PART 1 - REVISED DOCUMENTS ISSUED WITH THIS ADDENDUM**1.1 REVISED SPECIFICATIONS AND OTHER PROJECT MANUAL DOCUMENTS**

END OF ADDENDUM NO. 2

HURON-CLINTON METROPOLITAN AUTHORITY
STONY CREEK LANDING
AEW PROJECT #0215-0038

C08

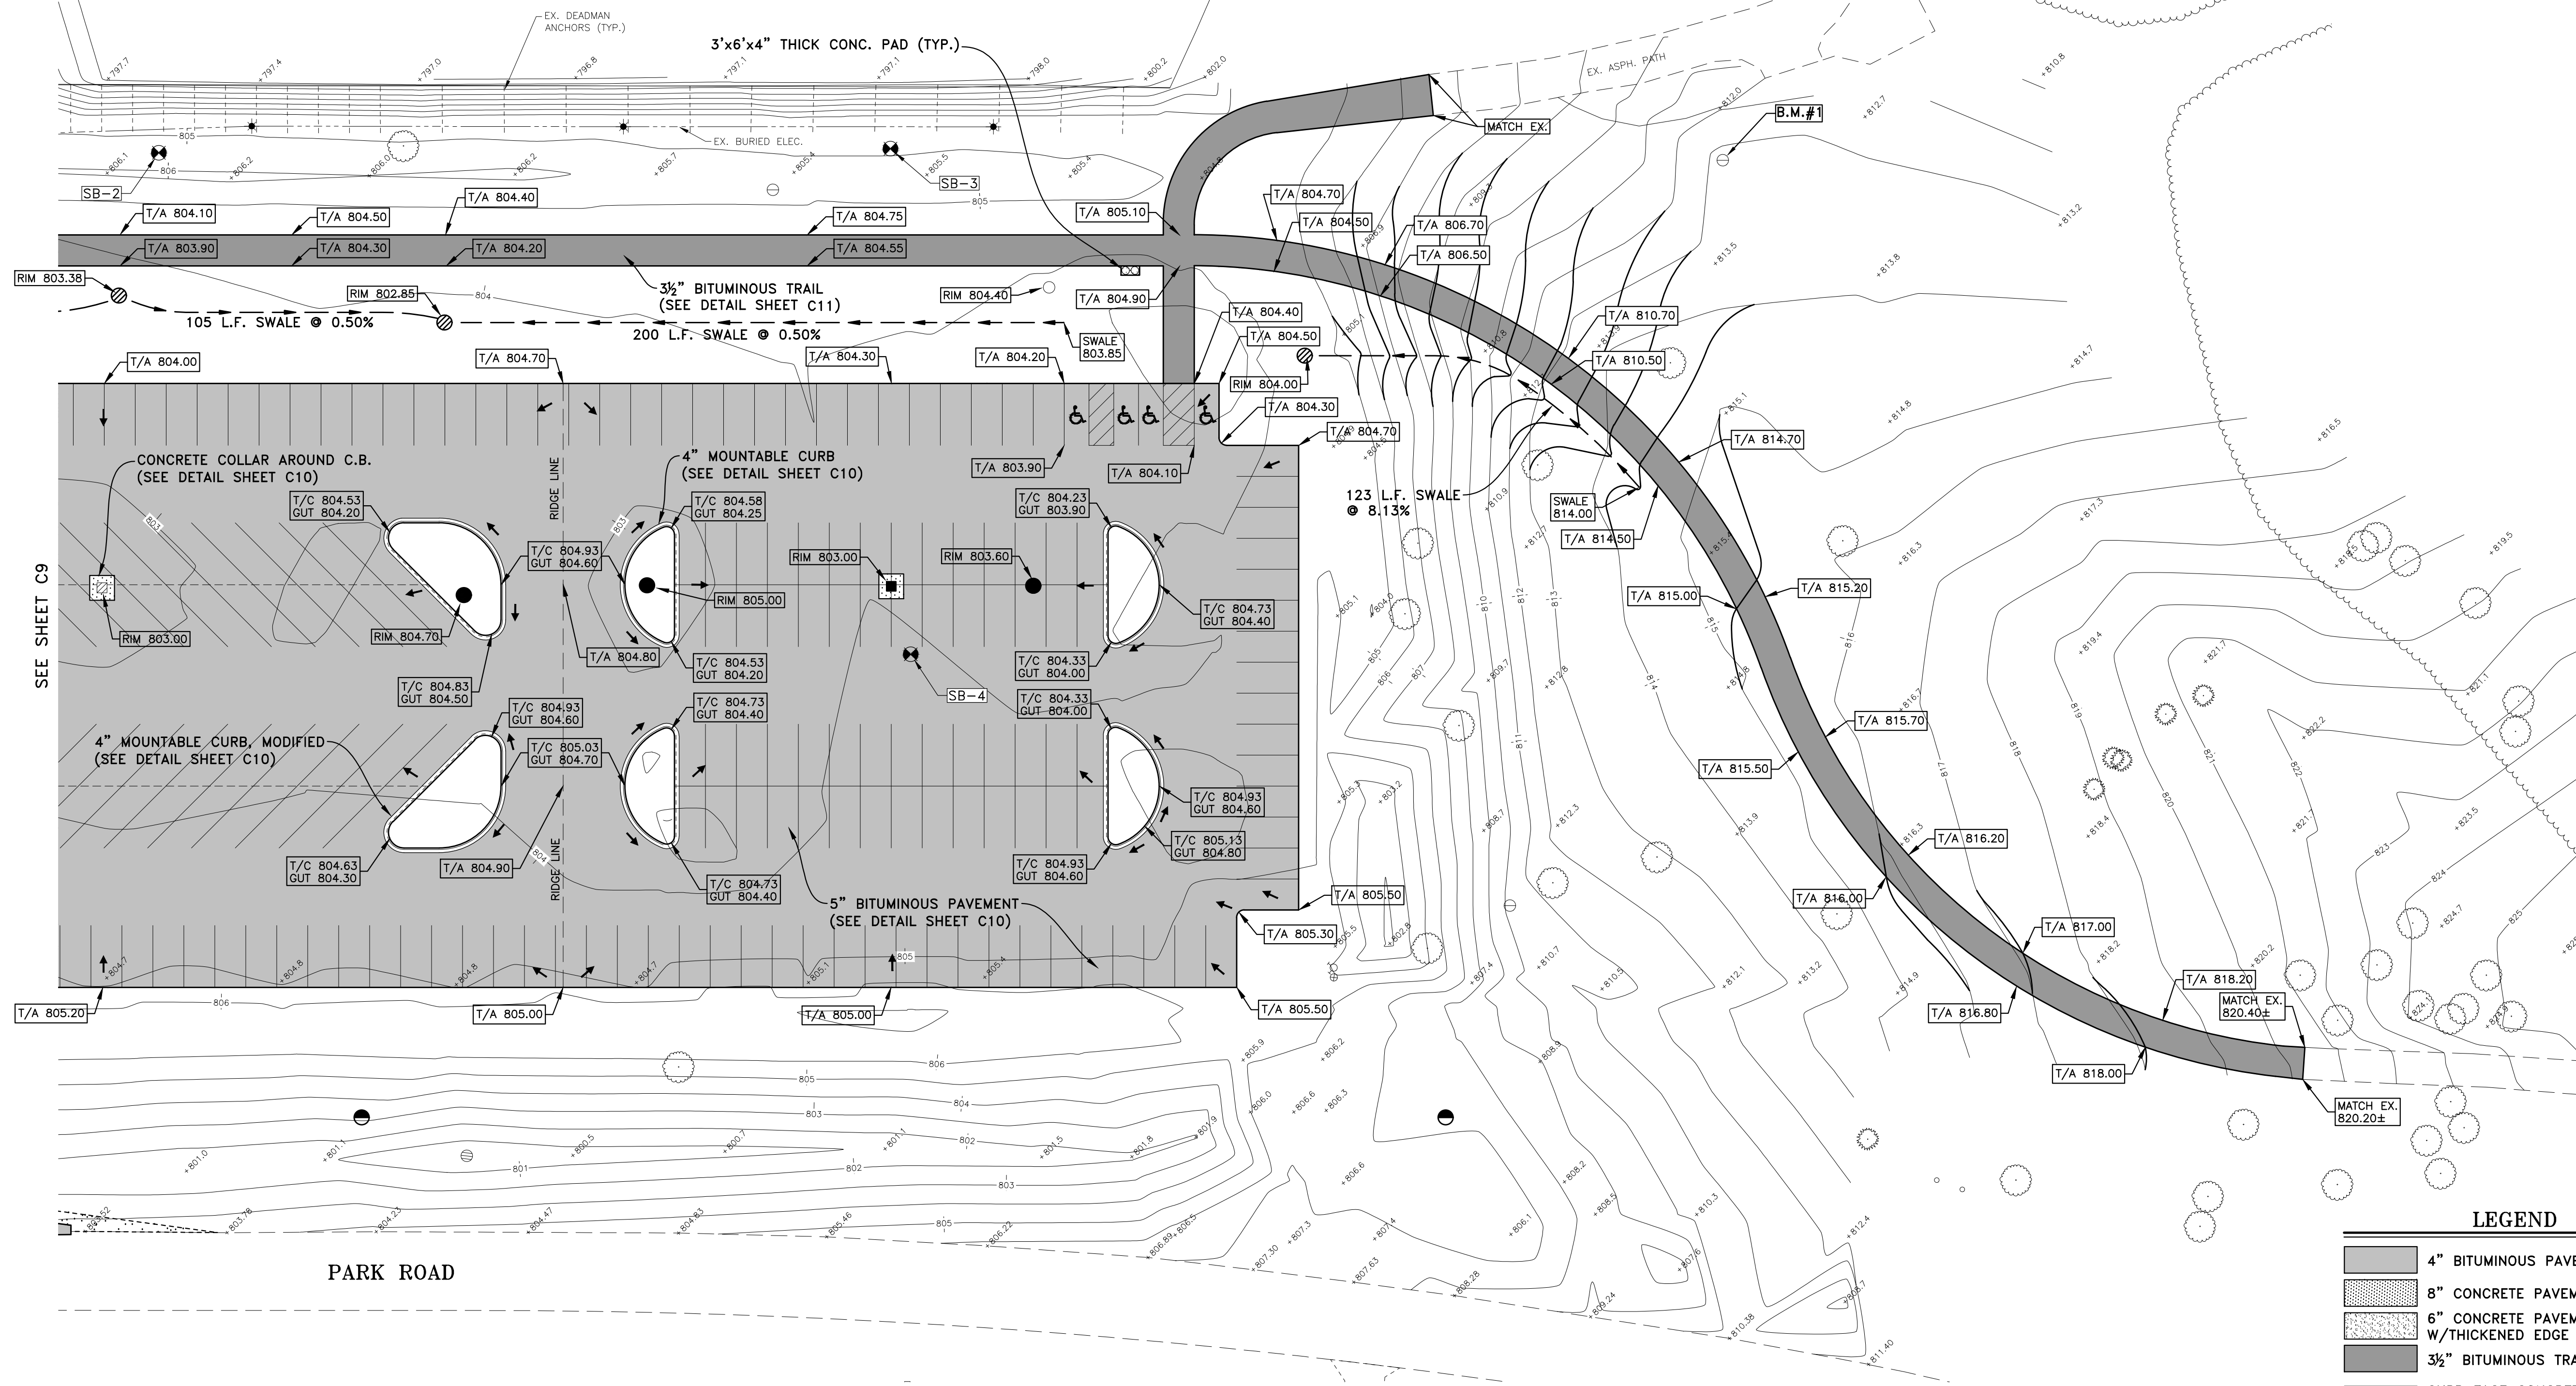
- A. SHEET NUMBER C8 – Paving & Grading Plan
This sheet shows a change to the legend. 6" exposed aggregate concrete with thickened edge was removed from the legend because it is not detailed within the civil plans. This item is included in the architectural plans and paid for with Pay Item No. 90.

C09

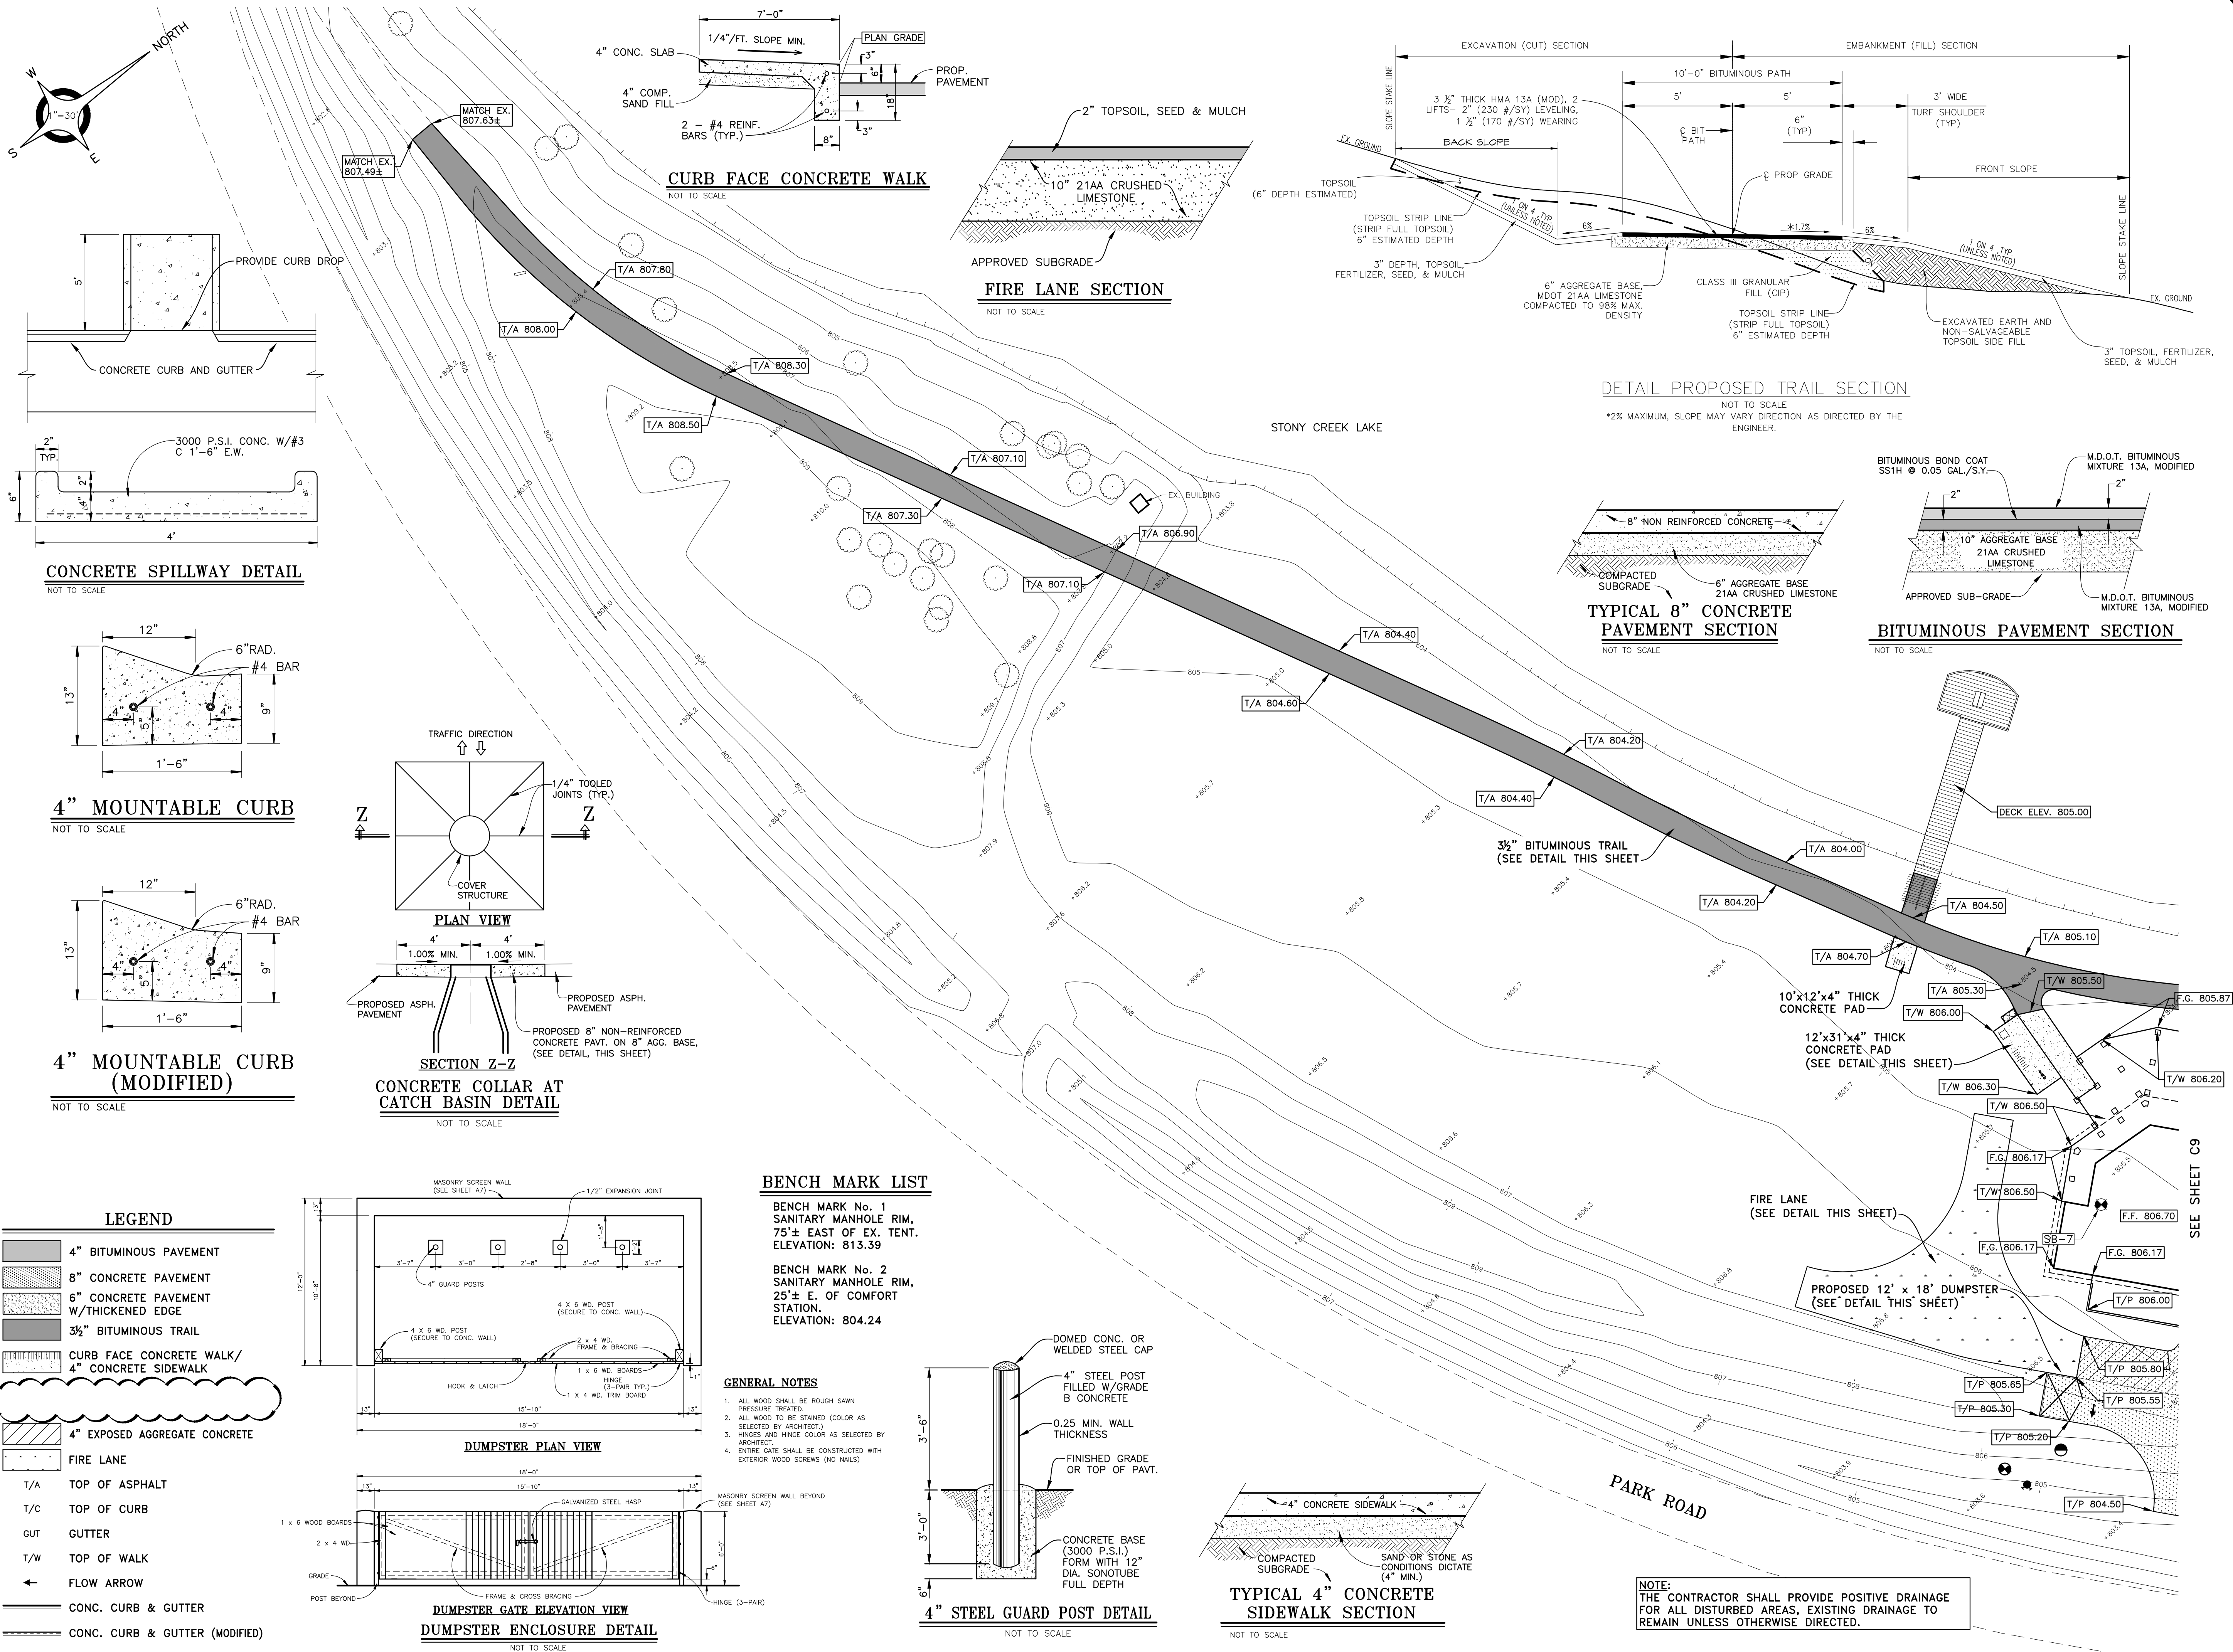
SHEET NUMBER C9 – Paving & Grading Plan
This sheet shows a change to the legend. 6" exposed aggregate concrete with thickened edge was removed from the legend because it is not detailed within the civil plans. This item is included in the architectural plans and paid for with Pay Item No. 90.

C10

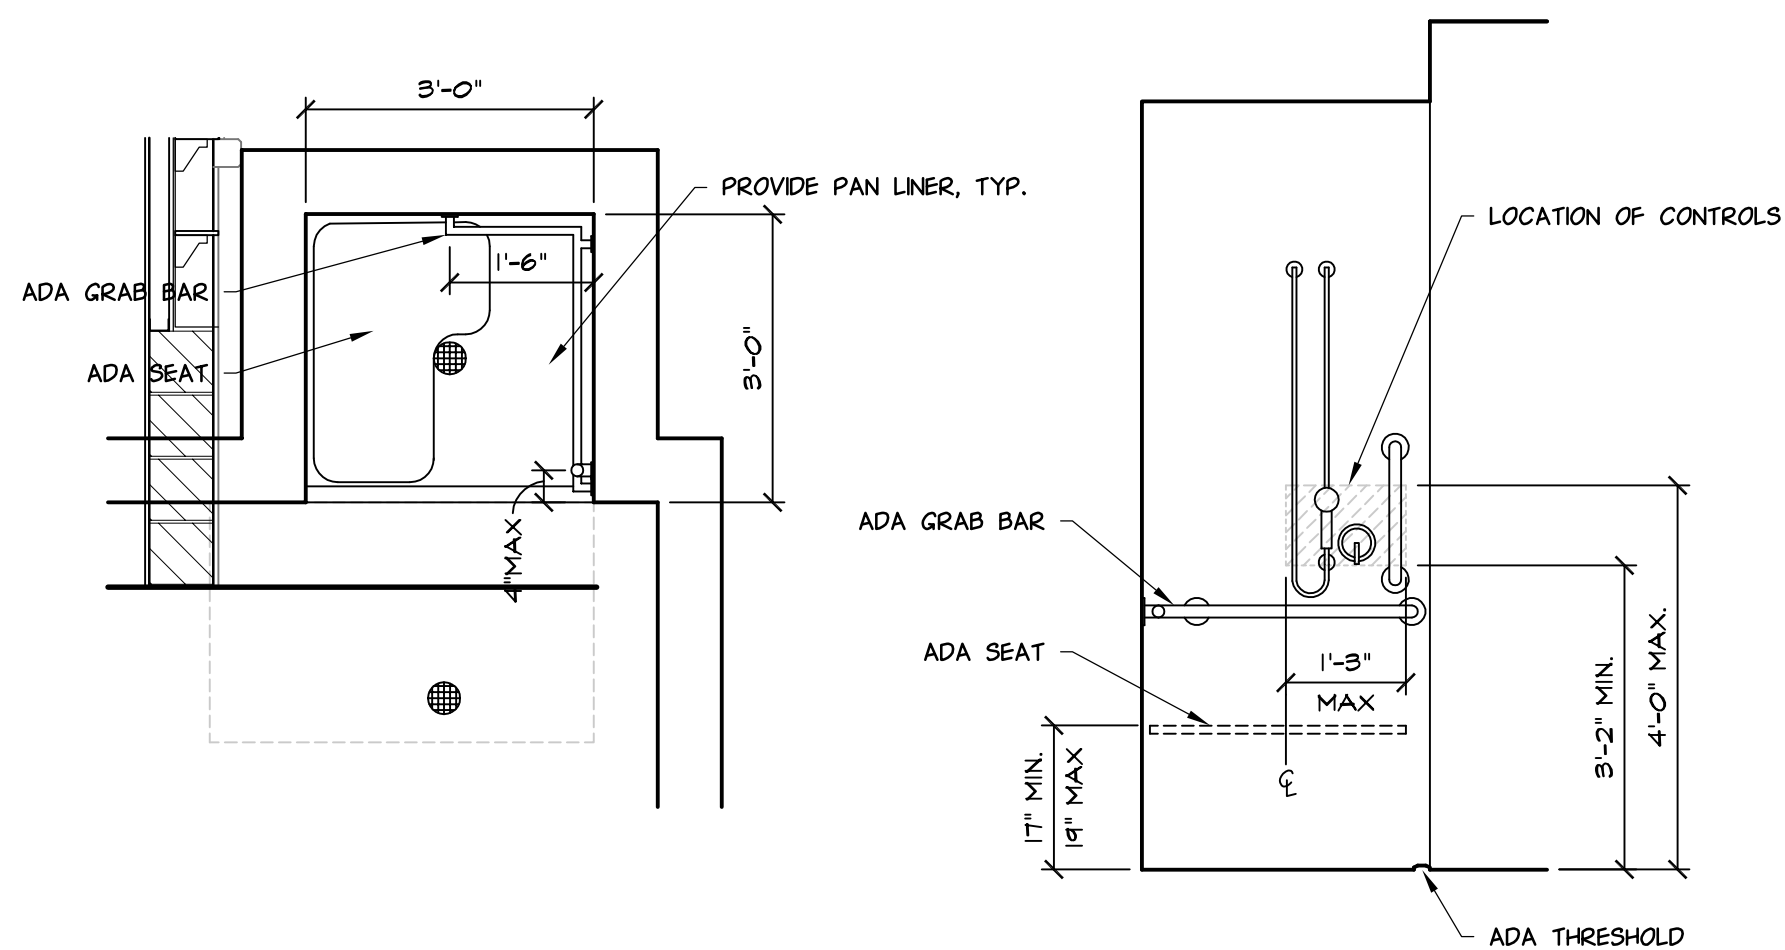
SHEET NUMBER C10 – Paving & Grading Plan
This sheet shows a change to the legend. 6" exposed aggregate concrete with thickened edge was removed from the legend because it is not detailed within the civil plans. This item is included in the architectural plans and paid for with Pay Item No. 90.
